TECHNICAL DEVELOPMENT MEETING

January 9, 2019

ELECTRICAL

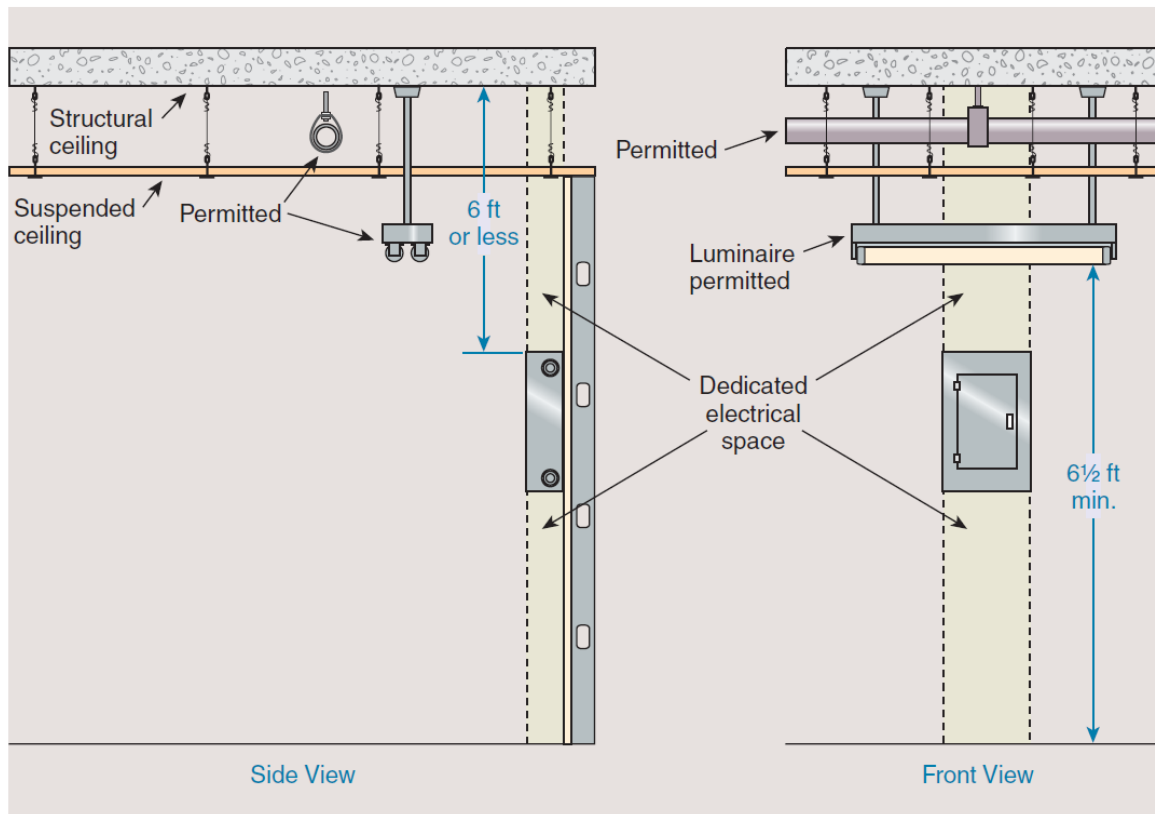
11. My panel board installation was turned down since I had air ducts run directly over them violating the required 6' of dedicated space above the panels per NEC 110.26 E1 (A). May I

install a hard ceiling above the panel boards to get around this? The ducts cannot be moved, and I mounted the panels as shown on the stamped drawings.

As you can see in the above article, part (d) Suspended Ceiling. It states that the ceiling must add strength to the building structure. A suspended ceiling does not meet that requirement, see the illustration below. However, if you added a hard ceiling to the bottom side of roof trusses, that would add strength to the building structure. See the illustration below:

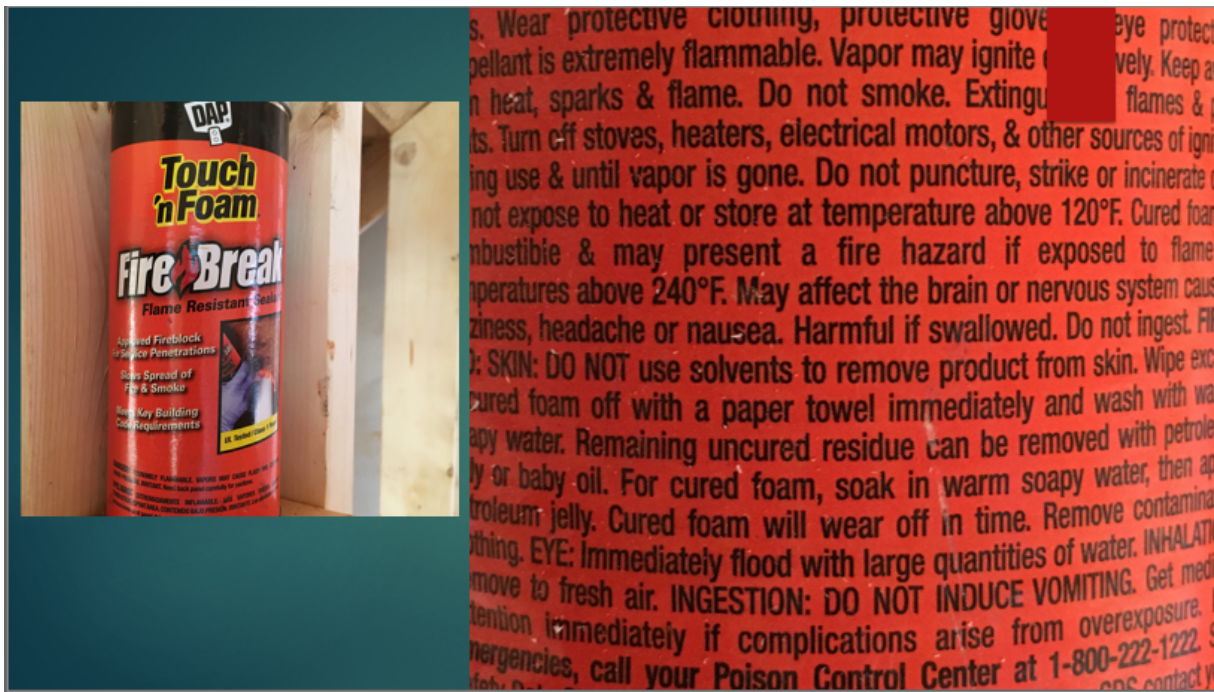
17. I was turned down for having my receptacle for the dishwasher behind the dishwasher. I have a switch ahead of the receptacle, what gives?

A. 422.16(B)(2)(6) Receptacle for D/W must be in cabinet space adjacent to D/W
